BUILDING COMPLETION REPORT

Re. Plot No. 639 Sheet No. Mr-3, Janesh Quarter.

Re:- Plot No. 639, J.M. 3, Jamshed Quarter.

With reference to your application dated 14-3-40,
with a plan for the proposed buildings/additions and alterations on plot
No. 639 Survey Sheet No. J.M. 3, Janshed Quarter,
I have to request you to comply with the following requirements—

AMENDED
PLAN SHOWING PROPOSED BUNGLOW ON PLOT
NO 4/7. J.M.3. JAMSHED QUARTER.
SCALE 8 FEET TO AN INCH.

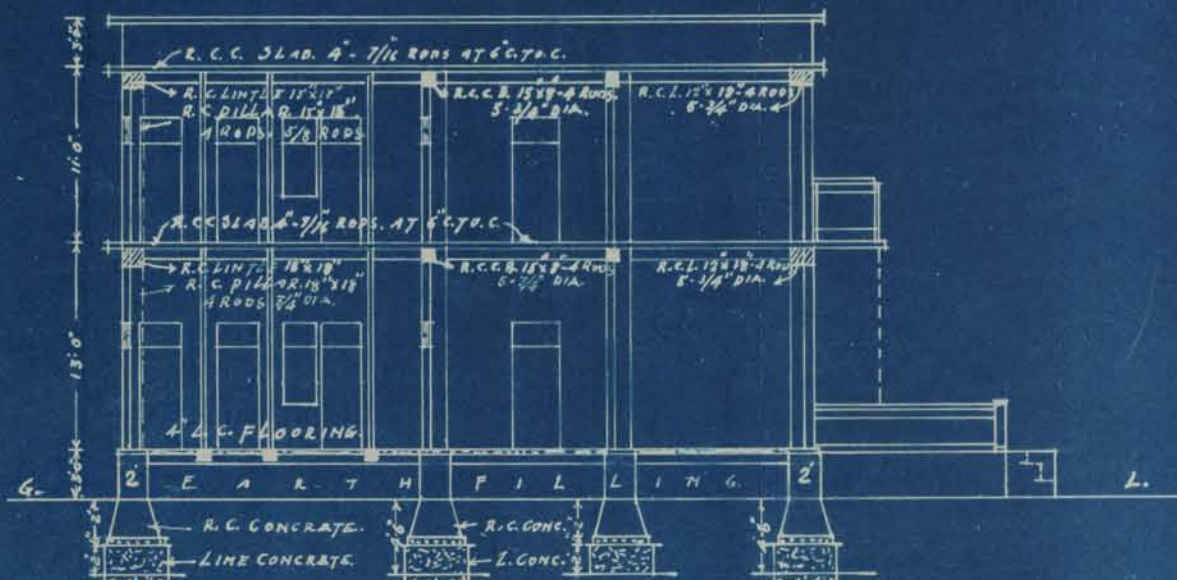
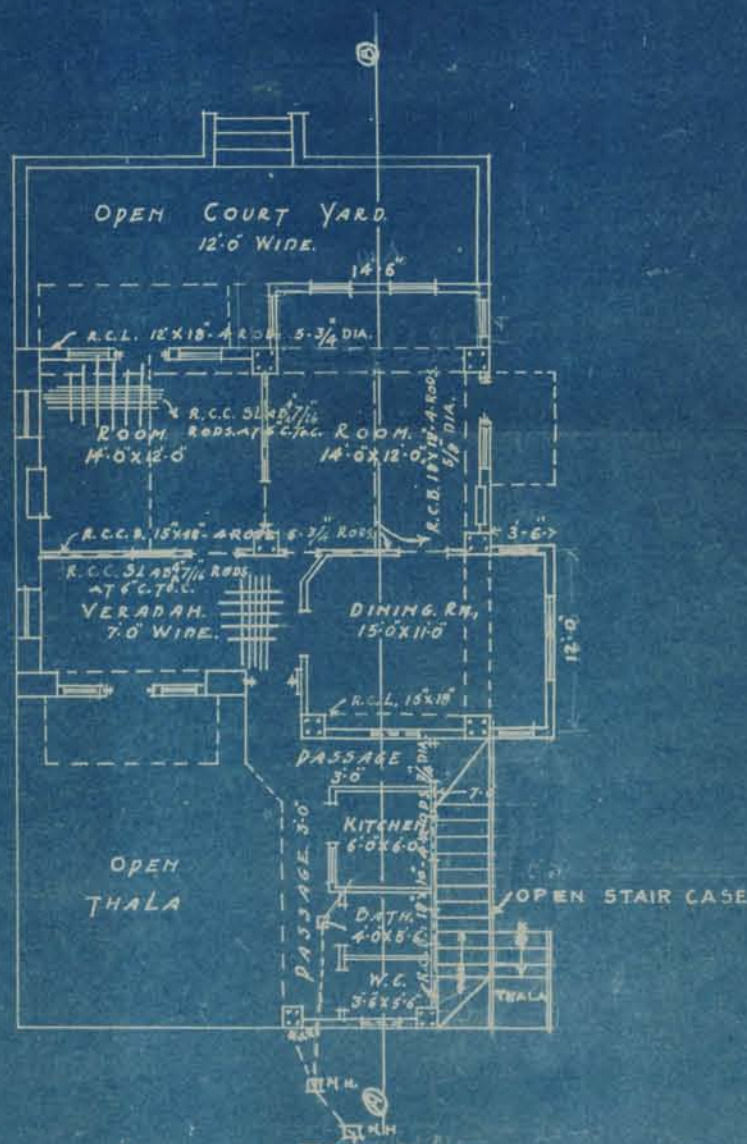
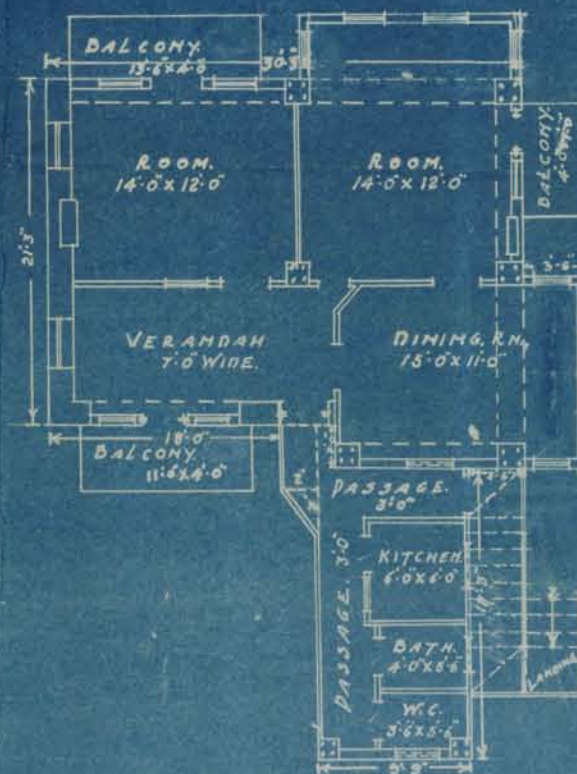
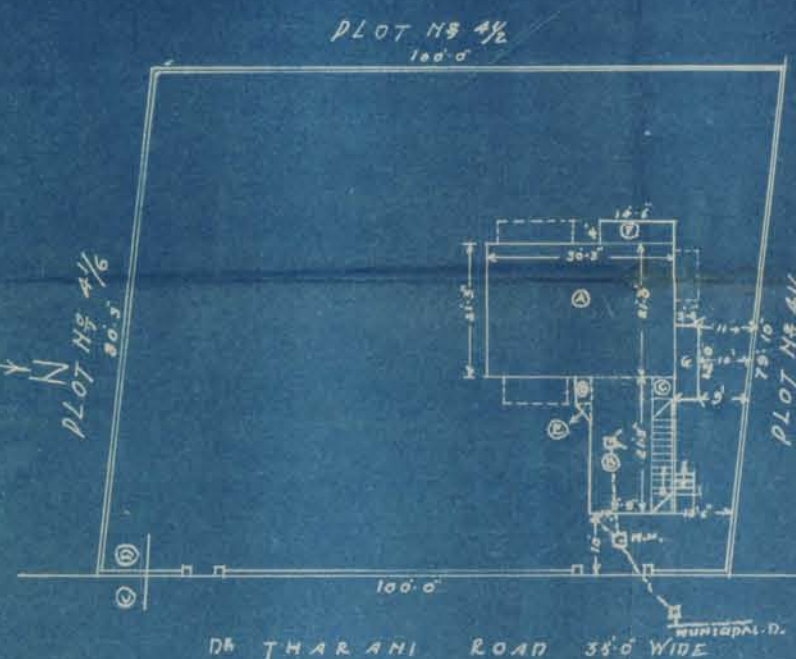
(1) Thalla and steps and bay window cannot be allowed
in 10 ft. compulsory open space.

(2) your statement in para. no. (4) is not correct.

1 Thalla & Bay window
Can not be allowed in
10 ft - Compulsory open
space.

1. Bay windows is kept 10' away while thalla^{of thalla} and steps₂ are allowed in compulsory space.

1. Where plots abut on eastern road 10' is to be left from the road as such I have left 10' away from the road which is in order.
2. Bays which are also allowed within 10' and have been allowed by you in buildings of Basila Papal on the corner Of Clayton road and R.k. Sidva road. In this case you have allowed bays within 5' .
~~while~~ and further you have allowed bay in bungalow abutting Thariani road apposite the proposed building. In my case I have kept bay 10' at the centre from the compound wall. You will kindly allow this.
3. I have calculated bays in covered area.
- 4 The present owner is Mrs Gulibai Gulabrai and her name is in the register.
- 5 Section of compound wall is shown

AMENDED
PLAN SHOWING PROPOSED BUNGLOW ON PLOT
NO 4 1/2 J.M.3. JAMSHED QUARTER.
SCALE 8 FEET TO AN INCH.

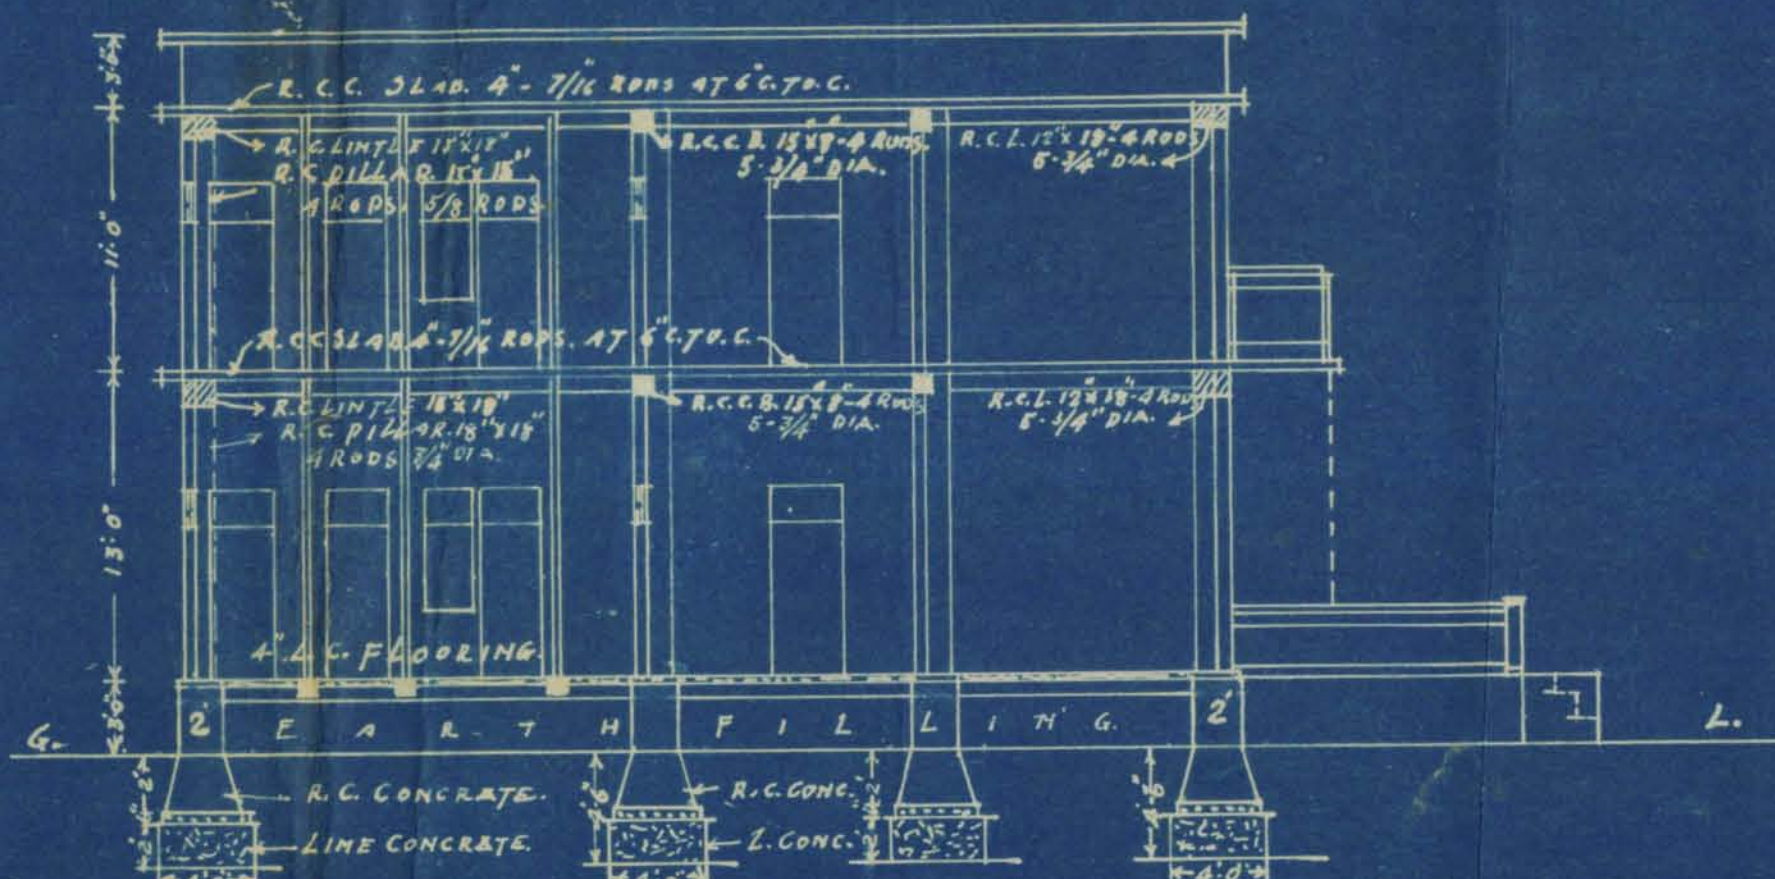
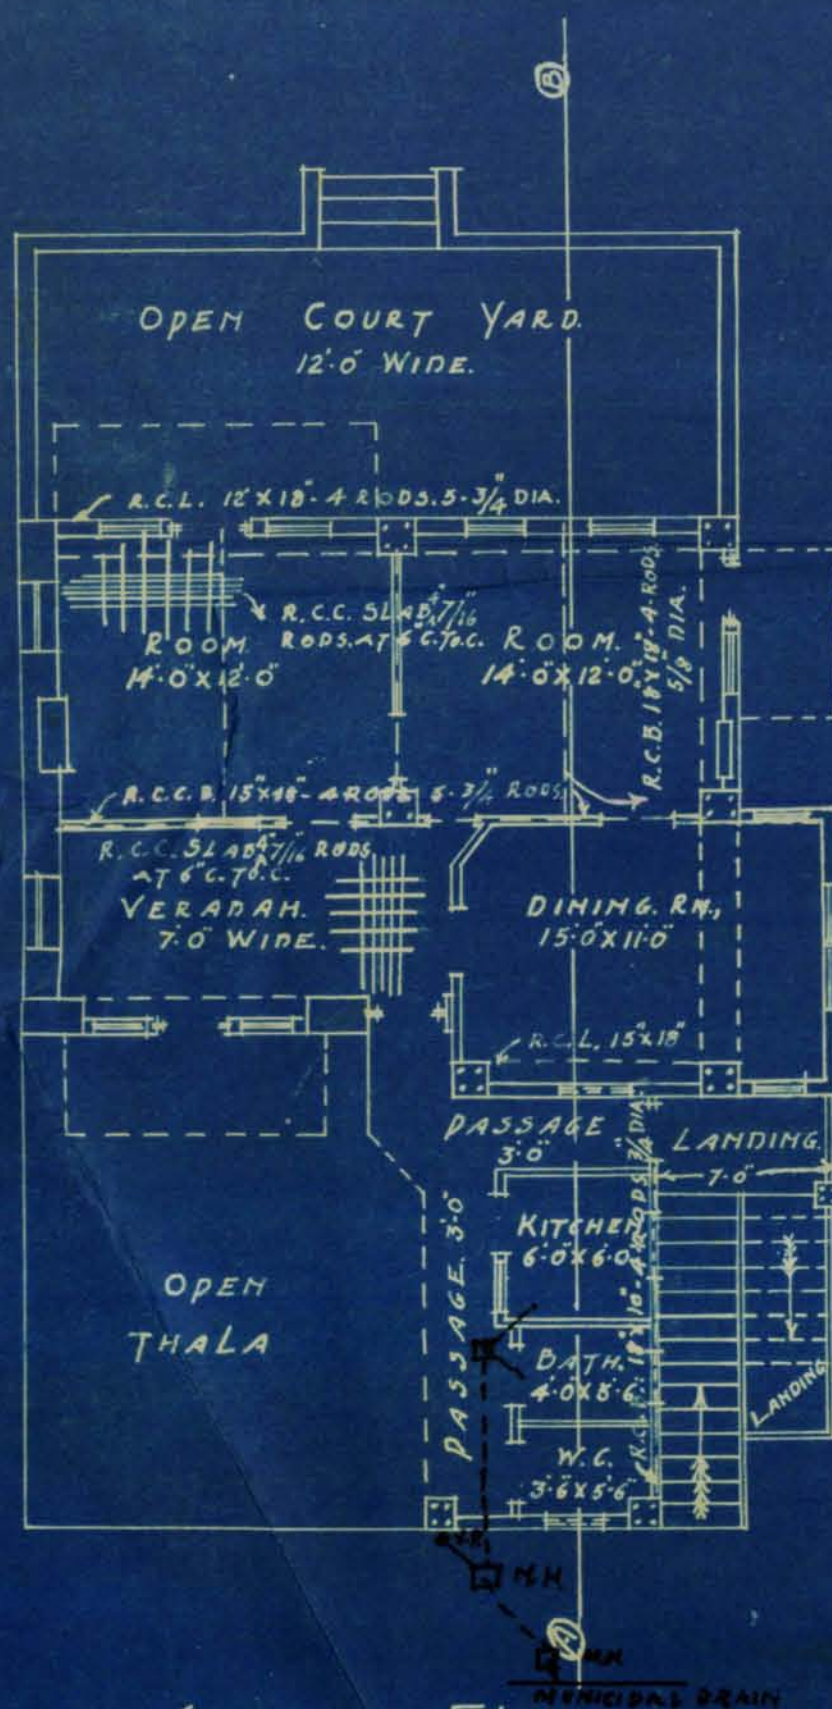
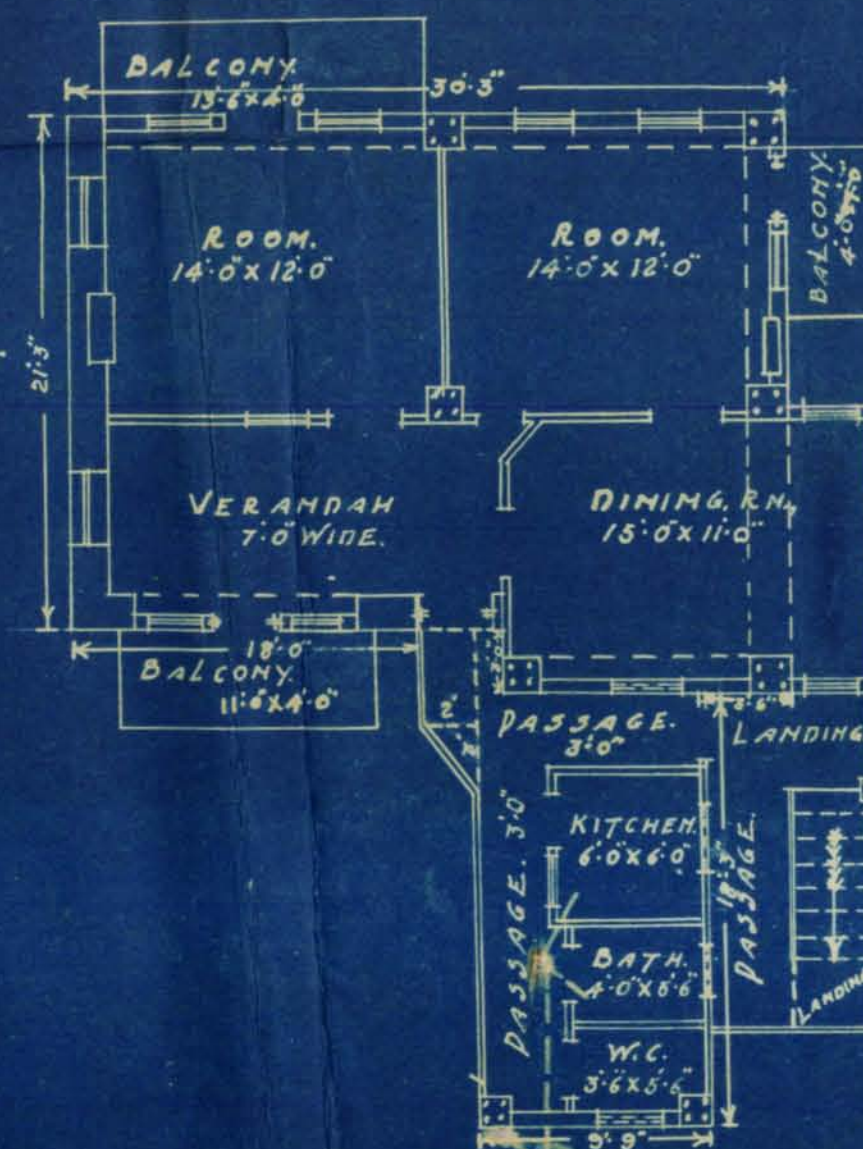
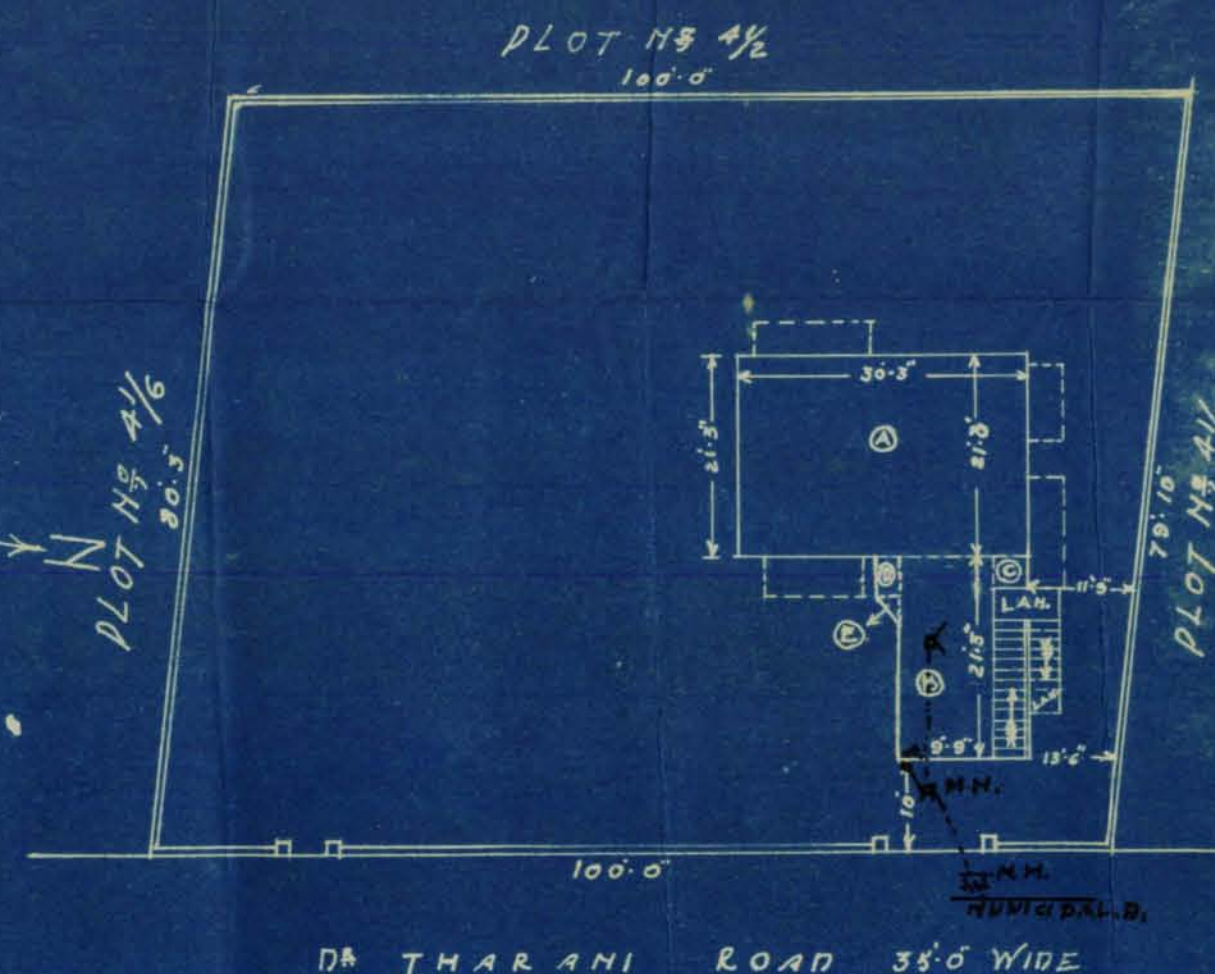
- (1) The building is not designed as per the conditions imposed which must be done and the plan drawn accordingly. No structure except platform can be allowed on the space of 15' from road and 10' from other boundaries of the plot.
- (2) Bay window must be taken into built up area as per conditions of sale.
- (3) Plans must bear the signature of the owner of the plot.
- (4) Stairs must be indicated as "open to sky" otherwise the same to be included in the built up area.
- (5) There is a mistake in the built up area calculations, ~~which~~ which must be rectified.
- (6) Section of compound wall must be given.

1. The building is not designed as per the conditions of imposed which must be done and the plan drawn accordingly. No structure except platform can be allowed on the space of 15'-0" from road and 10'-0" from the boundaries of the plot.

2 Bay windows must be taken into built up area as per conditions of sale.

3. Plans must bear the signature of the owner of the plot.

3. Stairs must be indicated as "open to sky" staircase. The same to be included in the built up area.

4. There is a mistake in the built up area calculation which must be rectified.

5. Section of compound wall must be given.
